HOLLYTREE FARM
BRODGAZE WESTON

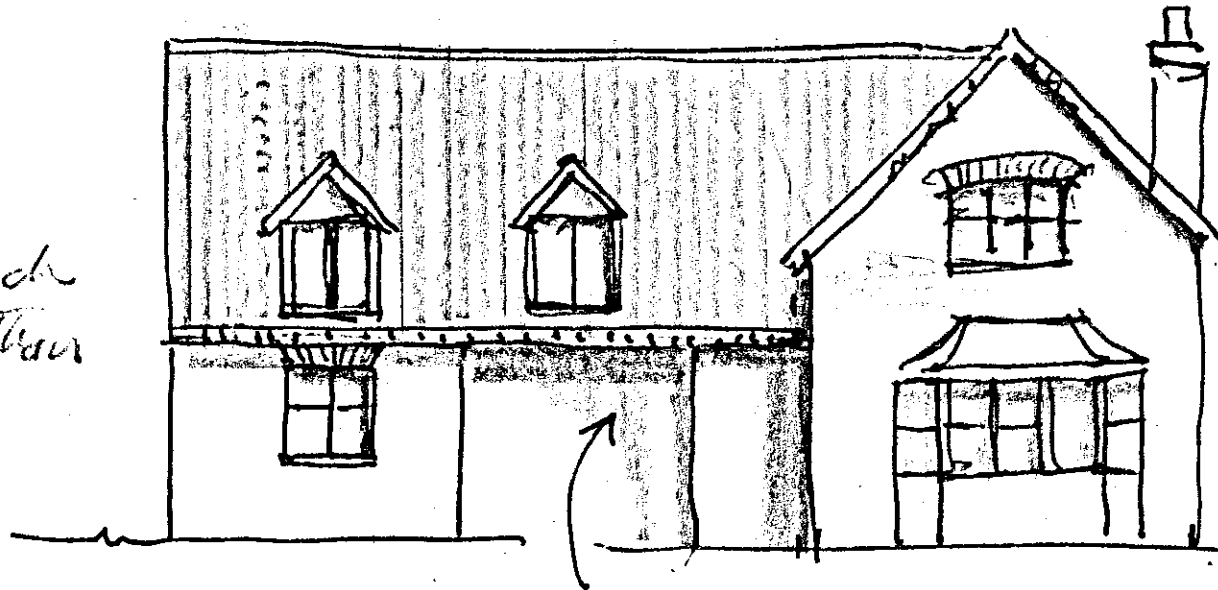
To make the
bay distinctive
carry it down
in brick

Flat arch
rather than
soldiers

Client wished
to reduce width
of lounge

Suggest reducing
width of dormers
and placing them
nearer the eaves
(May have over-done
this)

I don't think the detail of
this opening works with courses of brick
'floating' in the
air

Probably needs to be
narrower.

Have drawn this slightly too low
should sit under dentils
